Request for Sidewalk Waiver

Smuggler's Cove PUD (Final) Property at 14805 Windward Drive

Planning
Commission
June 23, 2021

Site Plan

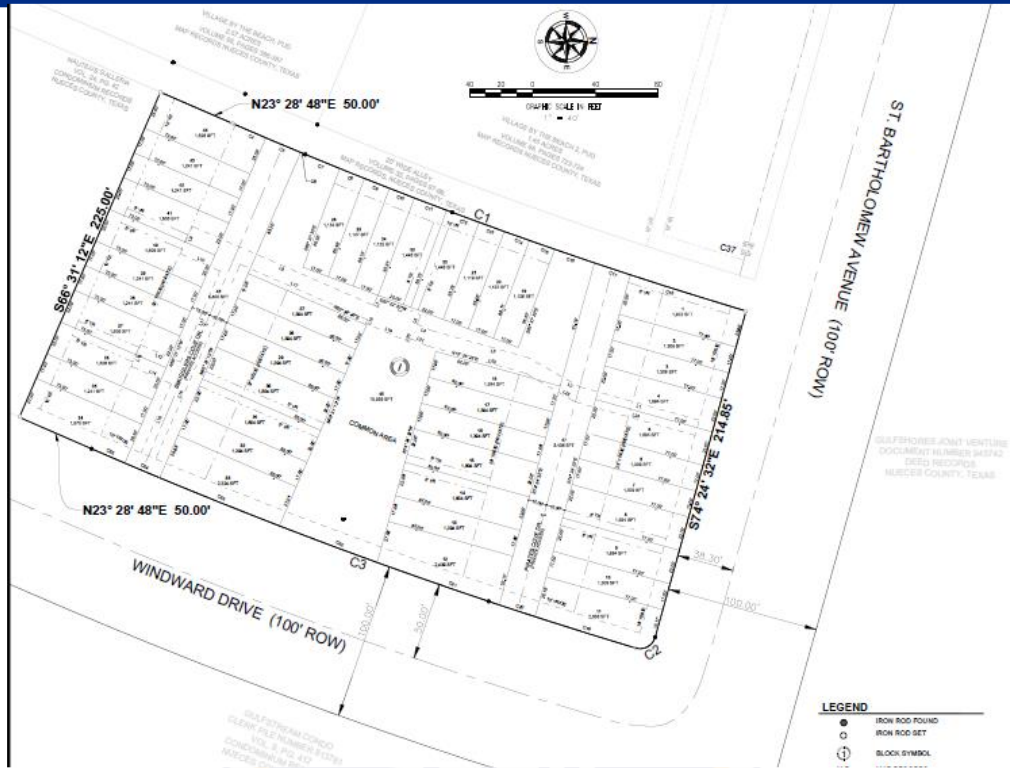
1. The property is zoned “RM-AT/IO” Multifamily AT District with the Island Overlay and located at a street corner. A street corner is the ideal place from which a sidewalk network can be provided meeting current standards for a collector street.
 2. Both Windward Drive and St. Bartholomew Drive are “C1” Collector Streets as per the Urban Transportation Plan (UTP) with a sidewalk network on both sides on the streets.
 3. The subject property is located on North Padre Island and is one of the busiest tourist areas in Corpus Christi. Providing the sidewalk facility is paramount to ensuring pedestrian safety.
 4. Both Windward Drive and St. Bartholomew Drive are listed on the Strategic Plan for Mobility.
 5. Windward Drive is listed on the ADA Master plan.
-

Denial of the request for a waiver from the sidewalk construction requirement.
